**RFT25-06-1 - City Hall 2nd Floor Renovation and Washrooms Plumbing
Replacement**

Addendum# 1

May 2, 2025

Project No. 23115 Drawing No. A101

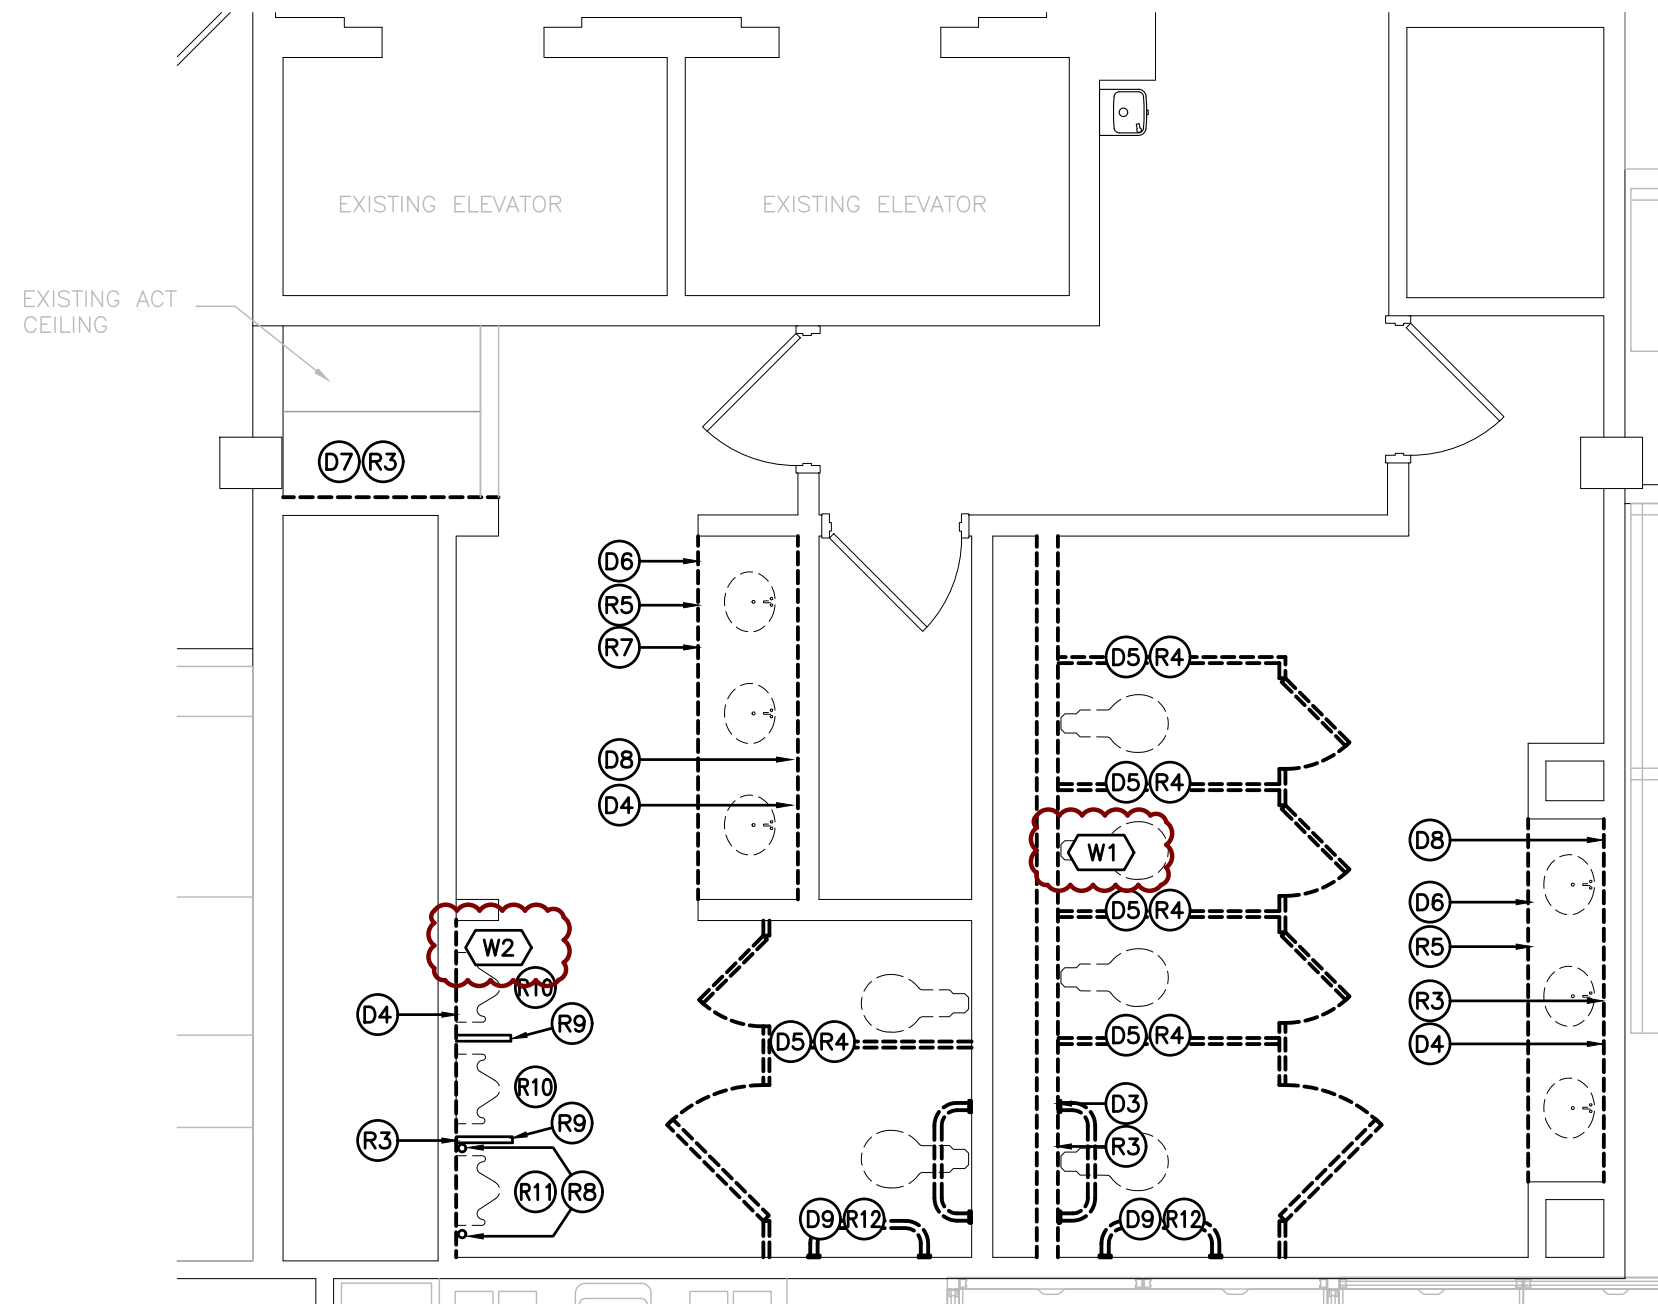
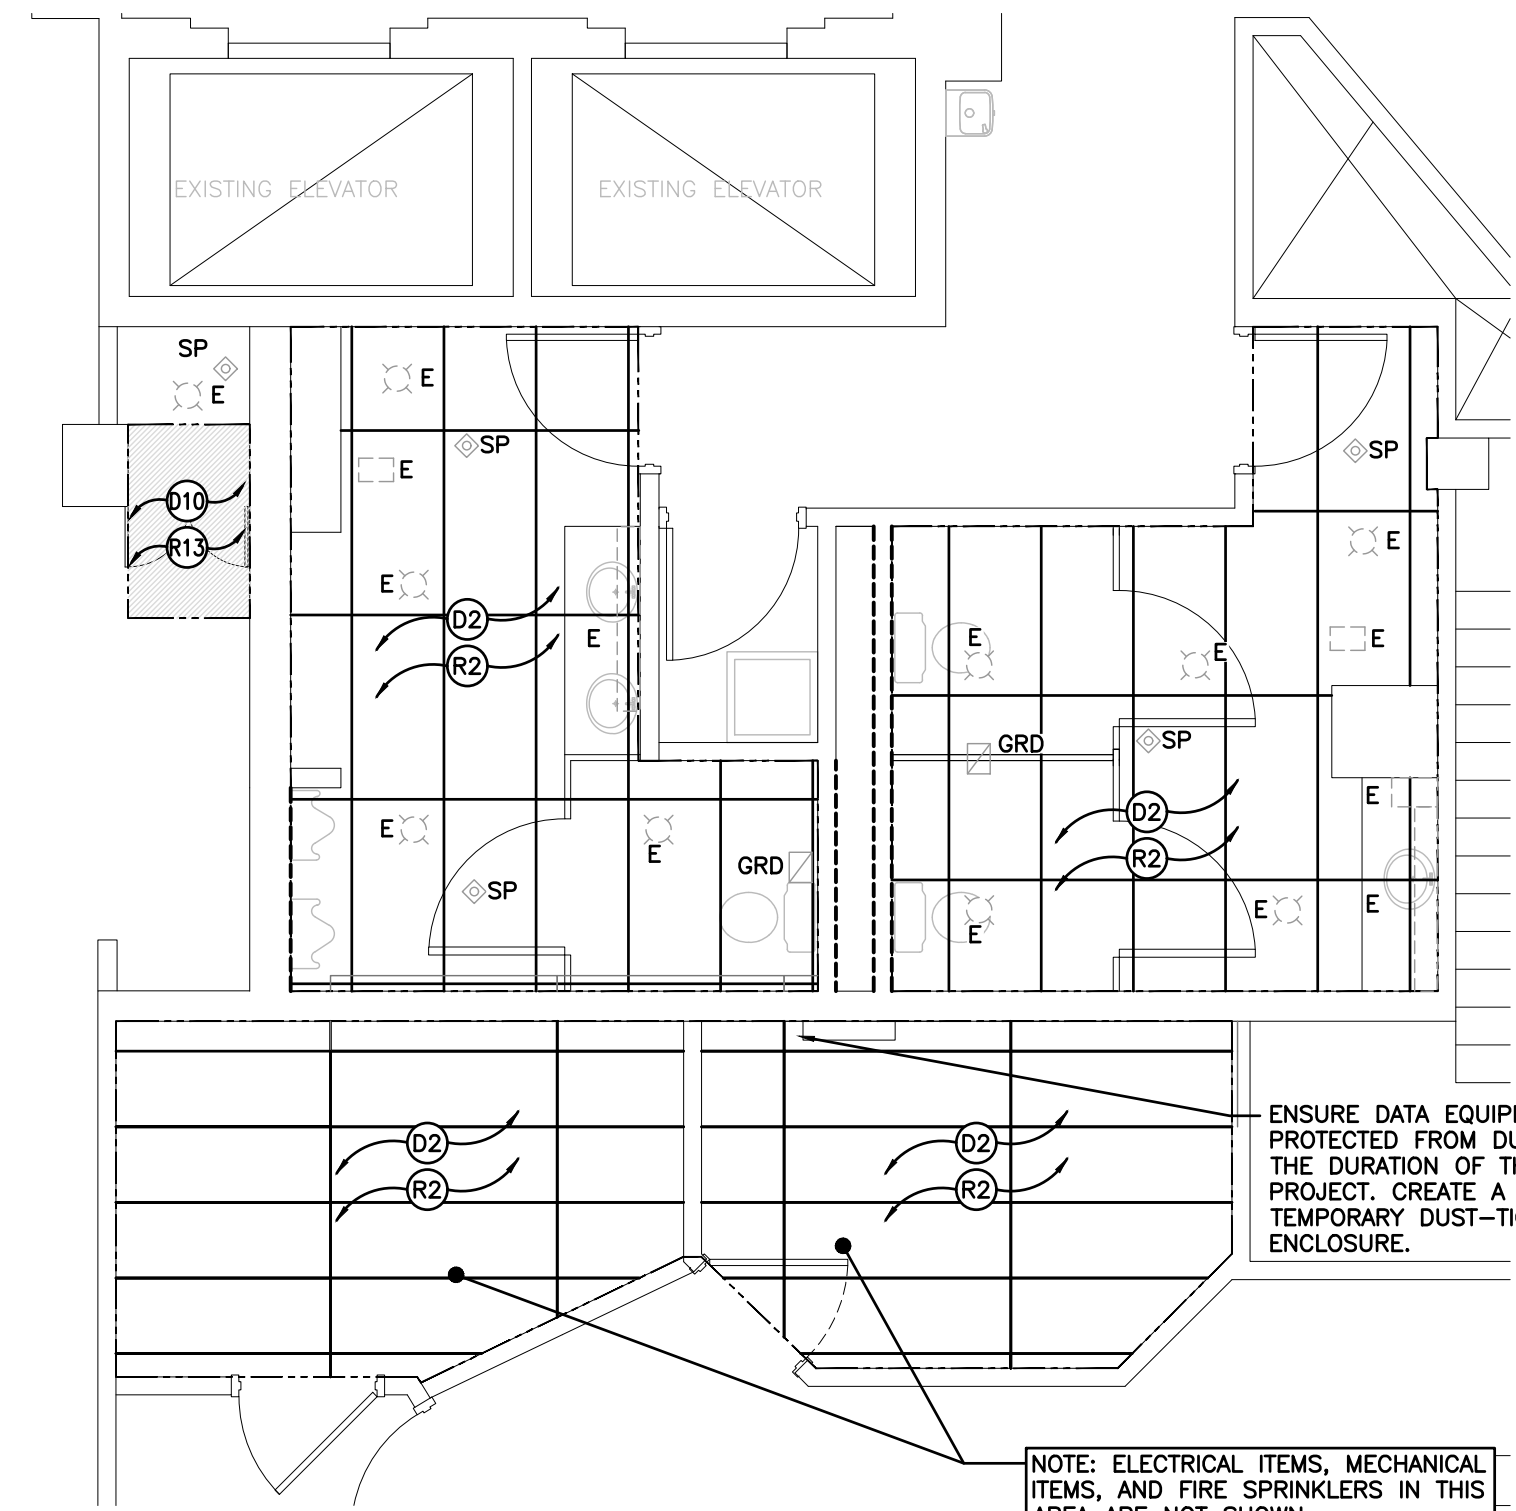
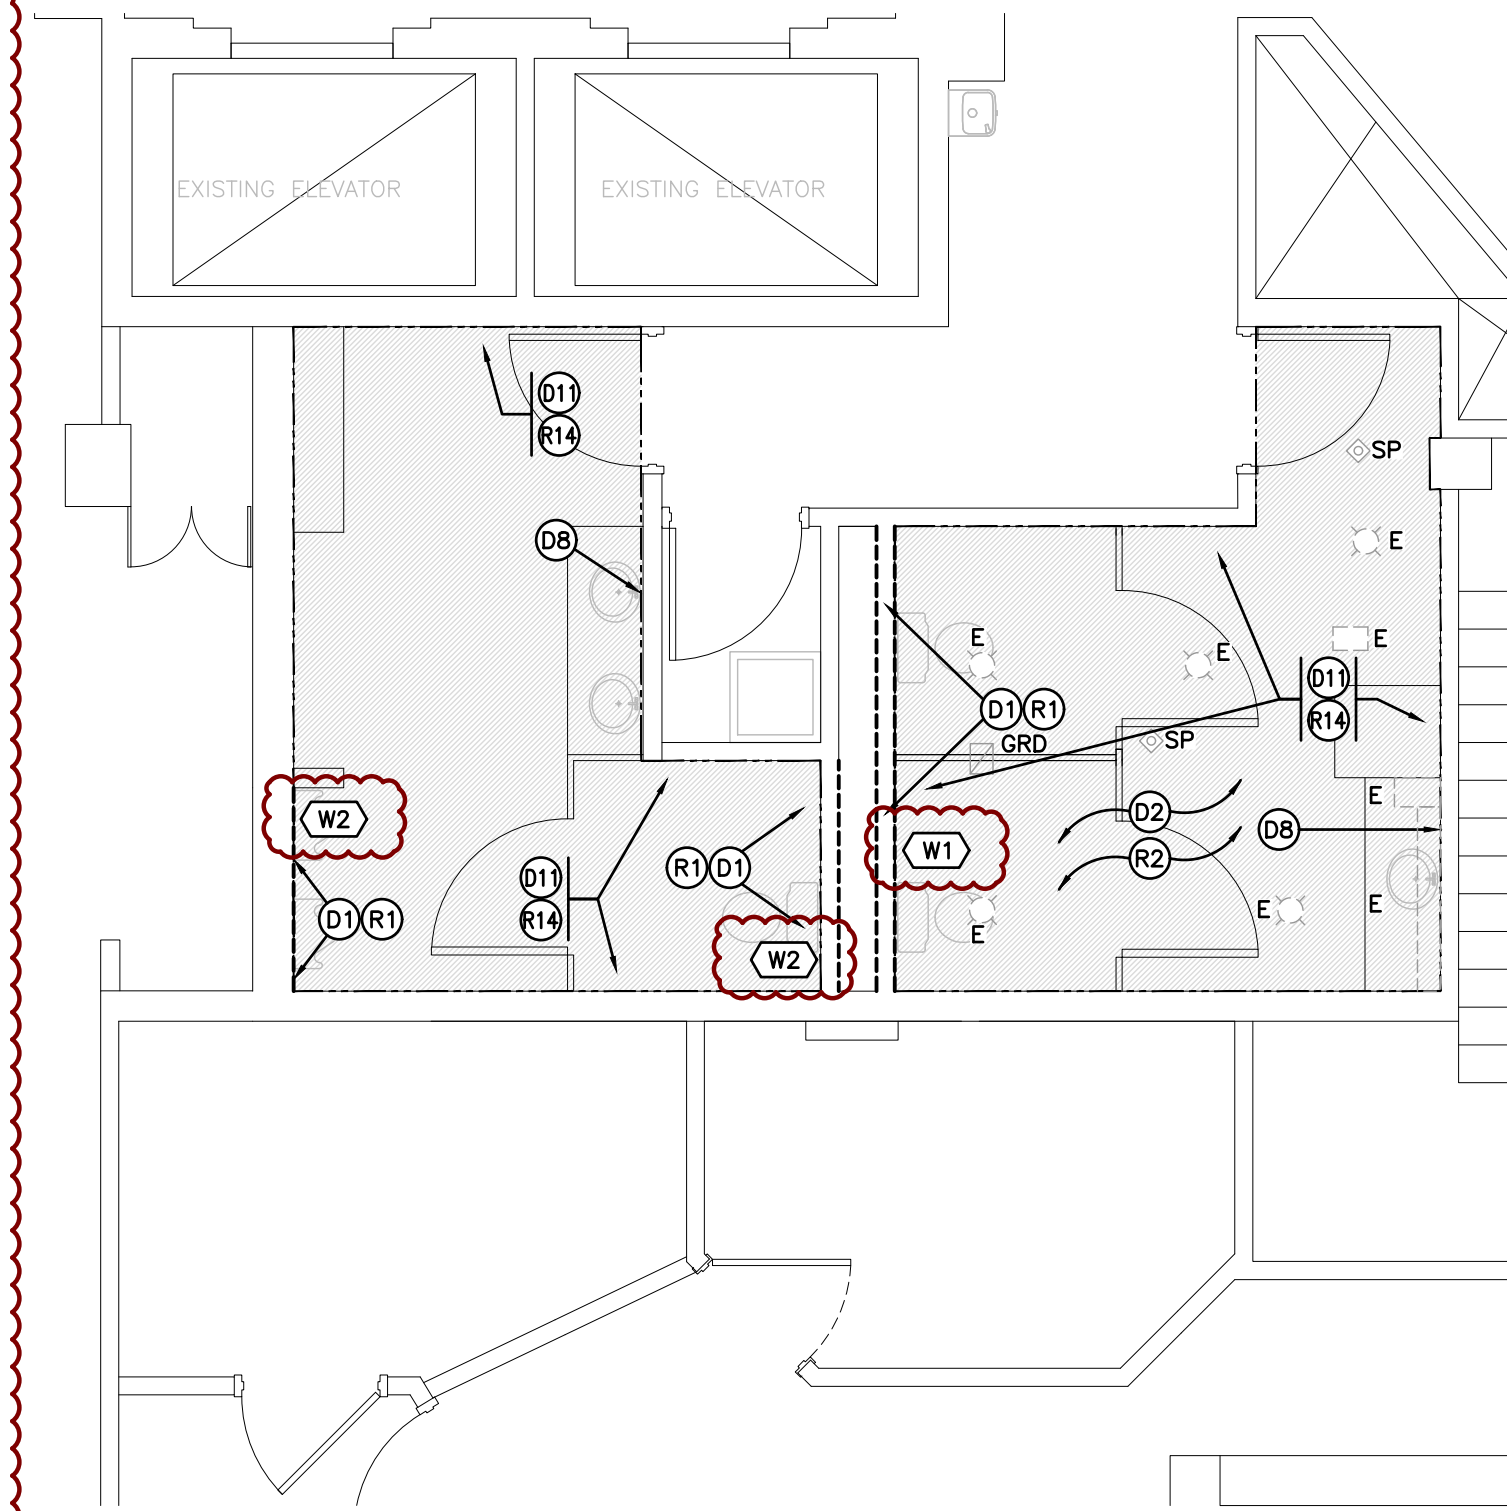
- 1.0 Reference Attached Reissued Phase 1 Drawing A101 and Attached Reissued Phase 2 Drawing A101
 - .1 Revise drawings to include wall assembly schedules.

- 2.0 Reference Attached Reissued Phase 2 Drawing A101
 - .1 Revise drawing to show ground floor reflected ceiling plan.

- 3.0 Reference Attached Reissued Phase 2 Drawing A101 and Attached Reissued Phase 3 Drawing A101
 - .1 Prepare non-static enclosure for data equipment located in space. Enclosure to be constructed of ductwork and sealed airtight. Take enclosure to wall of adjoining space and open 6"Ø hole through wall to let enclosure breathe. Ensure data rack remains dust free for duration of project.

Project No. 23115	Drawing No. A101
-----------------------------	----------------------------

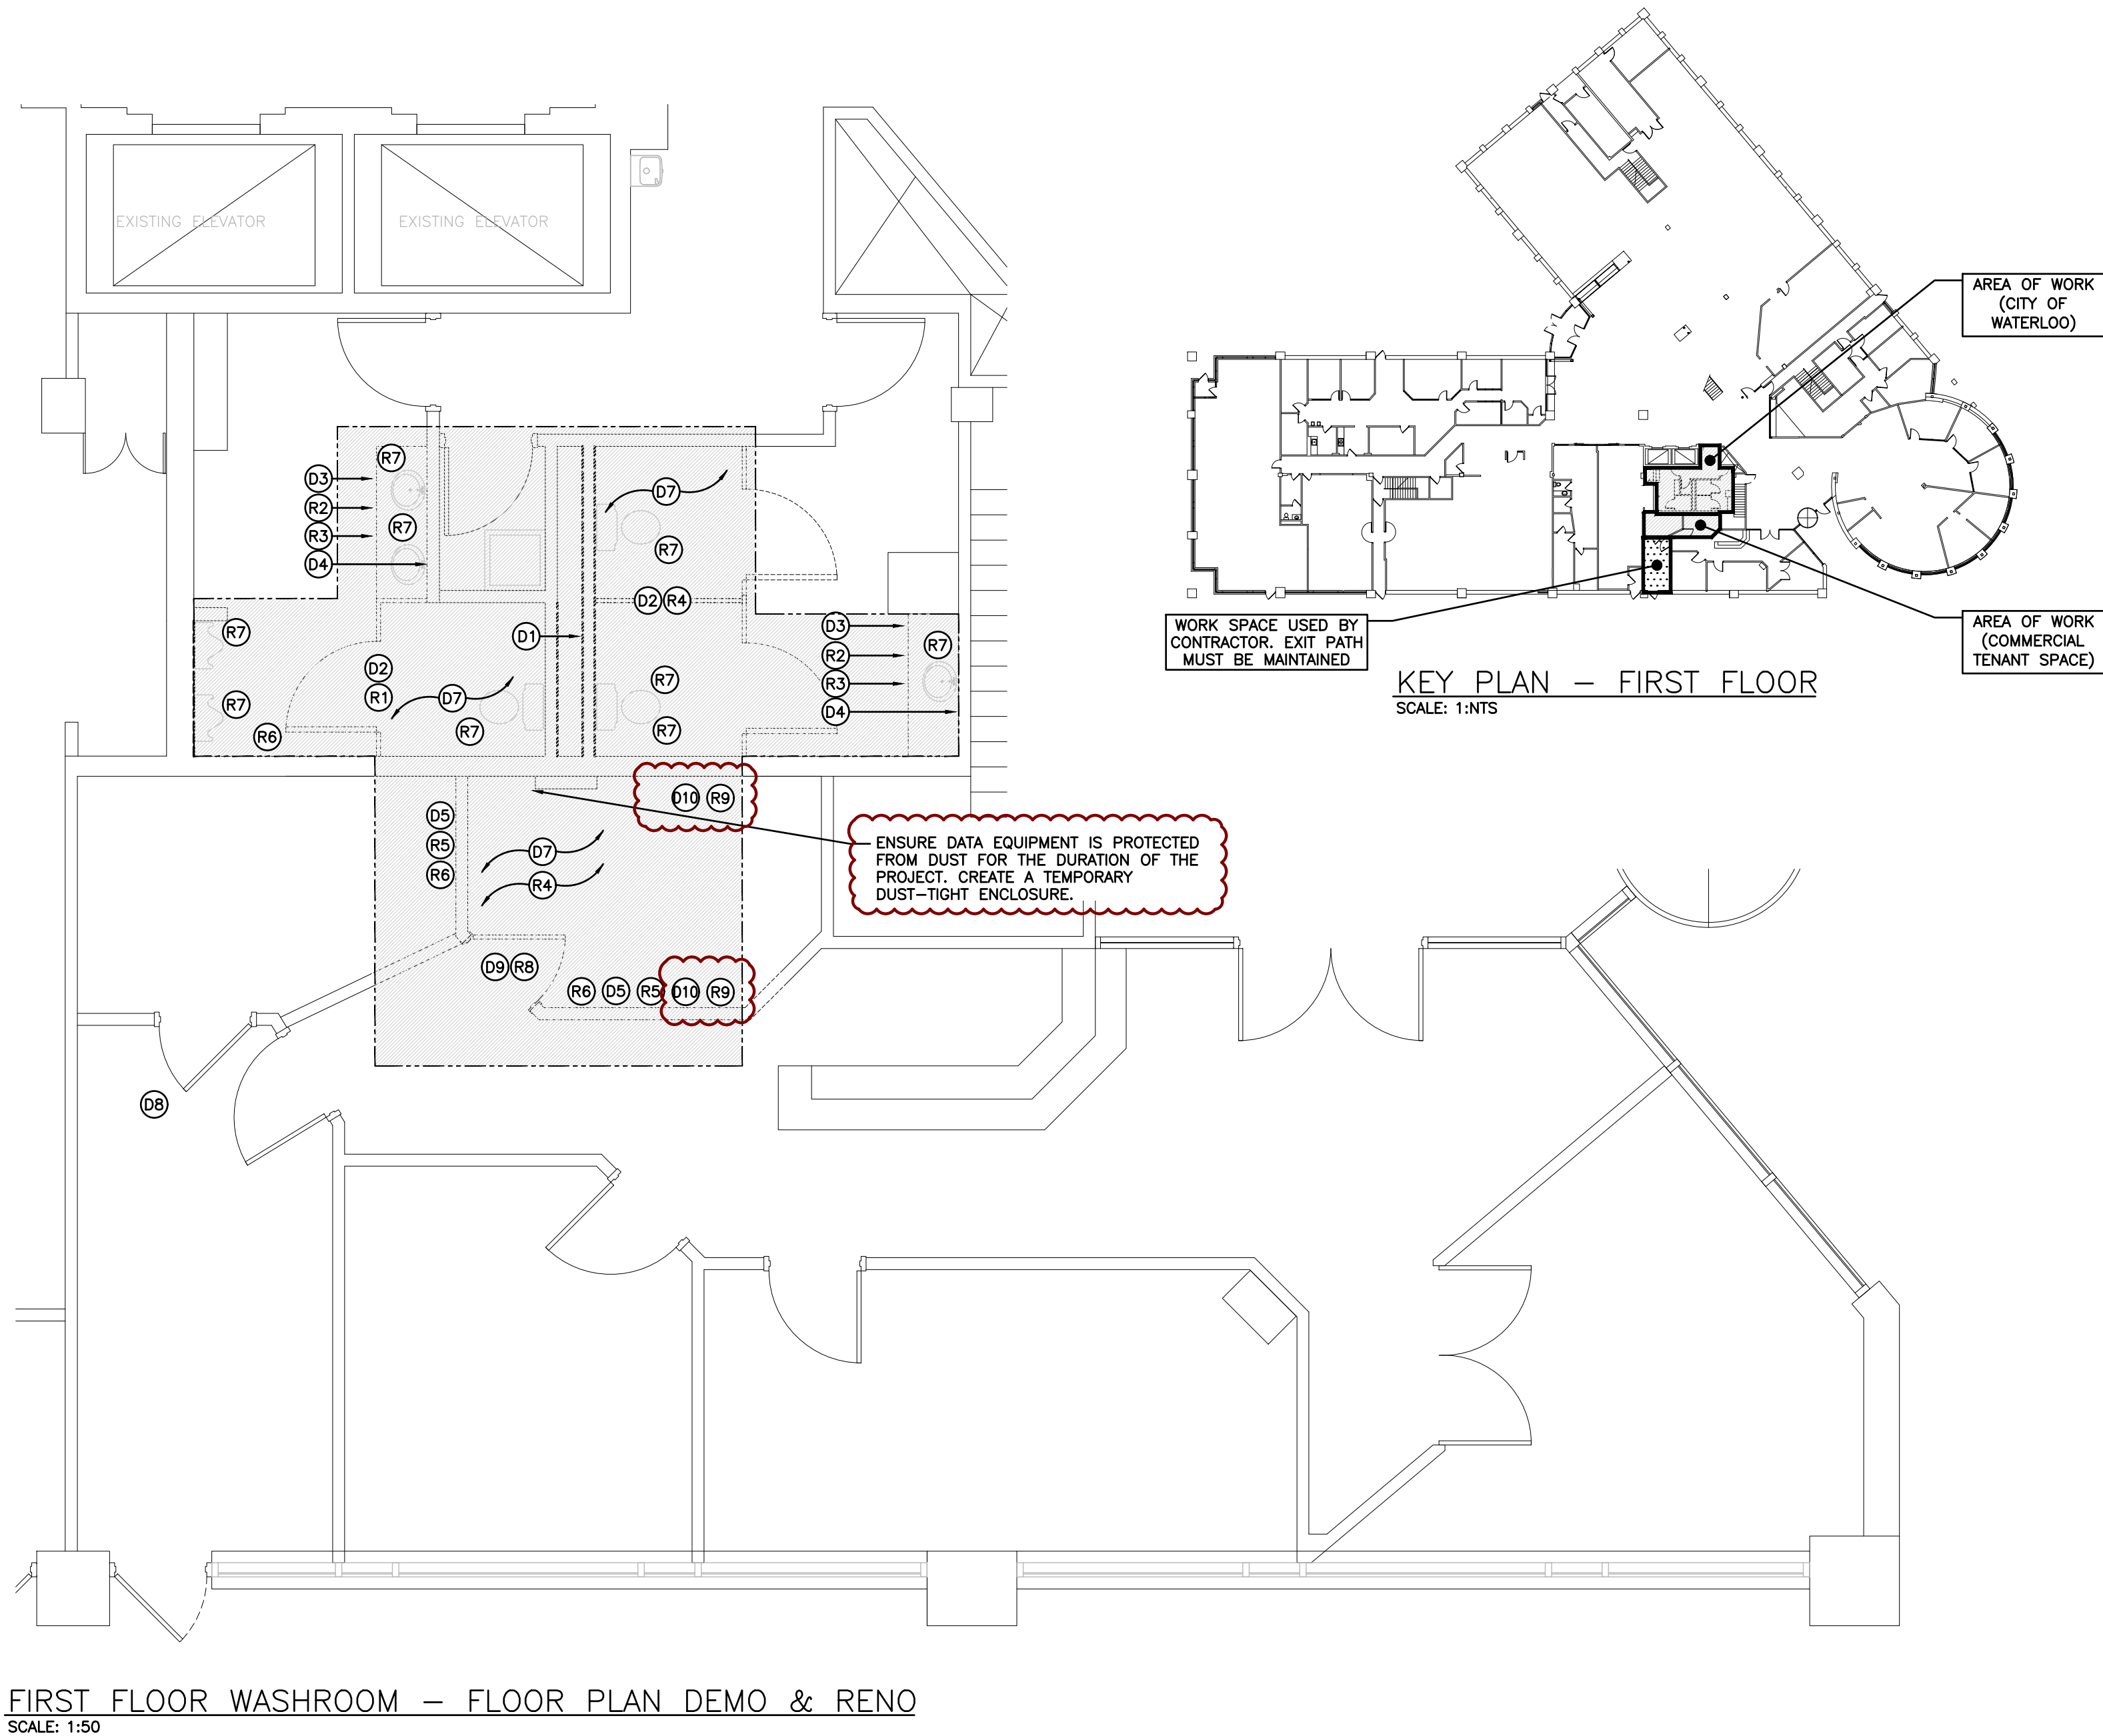
- 4.0 Reference Attached Reissued Phase 3 Drawing A101
 - .1 Remove, store, and reinstall millwork in Raymond James tenant space in scope of work area. Contractor is to take photos of millwork prior to demolition and send photos to consultant and owner for signoff. Identify any existing defects on photos and in accompanying list. Await consultant/owner signoff of defects list prior to demolition.
